BBTB Date:	23 February 2021
BBTB Number:	BBTB-058
BBTB Title:	OmniCare Control Panels
System Description:	OmniCare Control Panel Internal Connections
Product(s) Affected:	BVOC32 - 64
Reference:	PRCR2347
Priority:	3

Figure 1 — Incorrect connection details

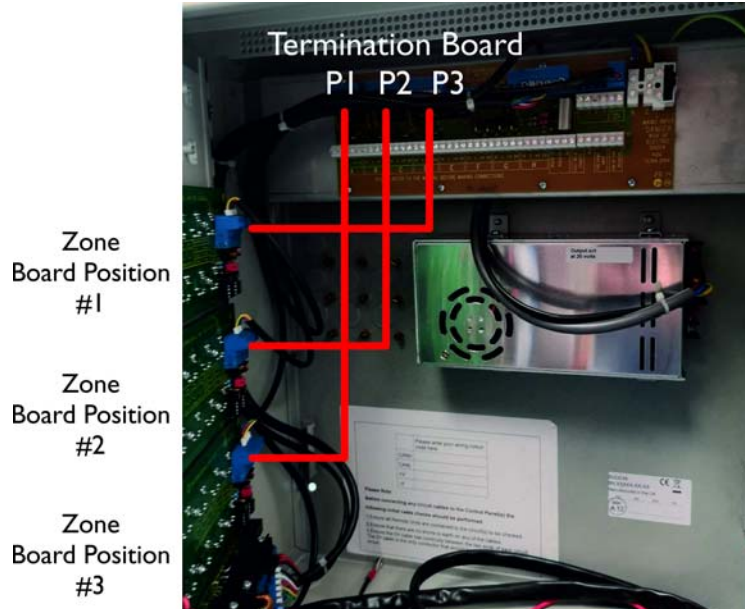
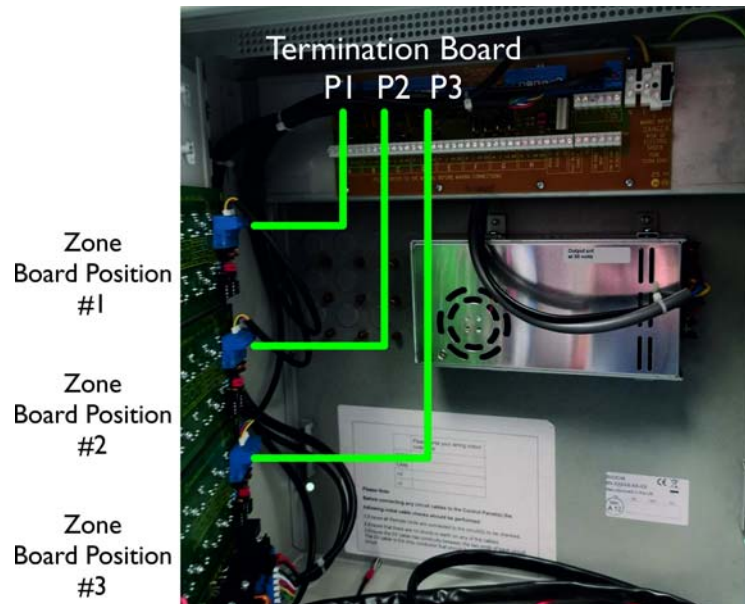
Baldwin Boxall has become aware of an issue with a small quantity of OmniCare Control panels built between October 2020 and February 2021. There was a build error in the internal connections between the zone PCB boards mounted on the door and the termination PCB mounted in the back box.

On affected units the connections on the front panel switch boards have been reversed, with P1 connected to the bottom board instead of the top board as shown in Figure 1. A 48 way panel has been used for these illustrations so there are three zone boards shown.

- Power down the control panel by disconnecting mains & batteries.
- Disconnect the cables between the termination board and the front panel zone boards.
- Carefully reconnect the cables in turn, ensure P1 on the termination board is connected to the top zone board, P2 should then be connected to the next zone board down (for a 32 way panel), P3 to the third zone board down (for a 48 way panel) and P4 to the lowest zone board (for a 64 way panel). Refer to figure 2 for correct connection details.
- Reconnect the Batteries and reconnect the Mains power
- Perform commissioning and ensure the correct remote (the first remote unit connected to termination “A”) is identified as #1.
